### **Proposal for Supplement 21 to the 02 series of amendments to UN Regulation No. 30 (Tyres for passenger cars and their trailers)**

#### **Submitted by the Working Party on Noise\***

## Supplement 21 to the 02 series of amendments to UN Regulation No. 30 (Tyres for passenger cars and their trailers)

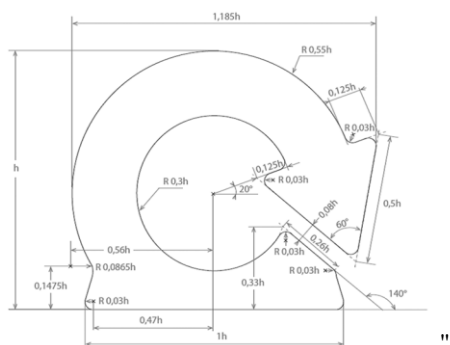
*Insert a new paragraph 3.1.15., to read:*

"3.1.15. The symbol below if the tyre is an EMT, where "h" is at least 12 mm.
